Technical Data Report Error Resolution Document

1. Originator: Paul W. Reimus/Ming Zhu	2. Date: 4/11/08	3. ERD No. TDR-CRW-GS-000001 ERD 01
4. Document Identifier: TDR-CRW-GS-000001 REV 02 ICN 01	5. Document Title: Yucca Mountain Site Description

Revisions to Figures and Tables of TDR-CRW-GS-000001 REV 02 ICN 01

Figure 3-21[a]. East-West Structure Section across Yucca Mountain Site Area [Addresses CR 2656, comment 23]

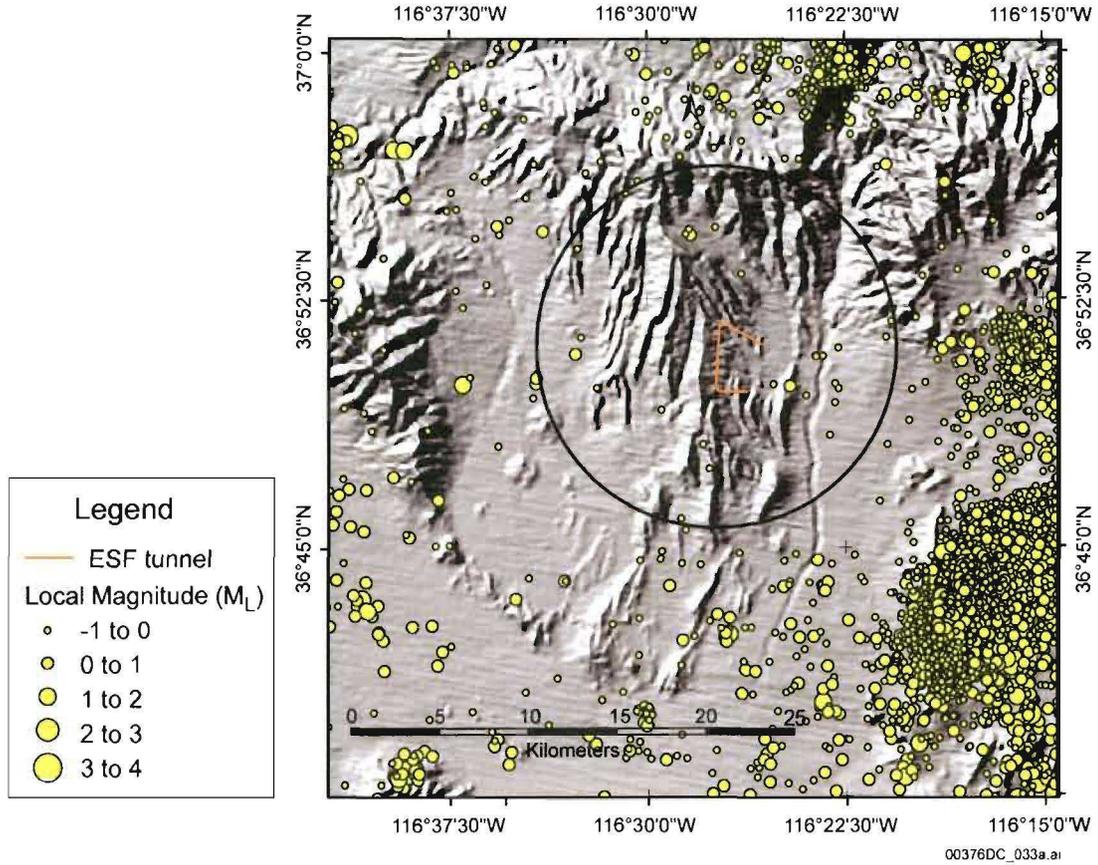
- (comment 23 of updated CR 2656 list) The label “Solitario Canyon-Bow Ridge/Paintbrush Canyon” in Figure 3-21 should be changed to just “Solitario Canyon-Bow Ridge”. See revised figure in Attachment A.
- (comment 25 of updated CR 2656 list) In Section 3.4.6.4, p. 3-57, the statement that the maximum and mean depths of erosion in the study area were about 1.8 m and 5 cm (6 and 1.6 ft), respectively, should be changed to “1.8 m and 5 cm (6 and 0.16 ft), respectively.” 5 cm is equal to 0.16 ft, not 1.6 ft.
- (License Application review comment added to most recent version of the CR 2656 list) In Section 7.9.1.2, p. 7-100, in the 5th line of this section, “TSw” should be changed to “TCw”. Also, the reference to Section 7.3 in the 7th line of this section should be changed to Section 7.3.2.1.
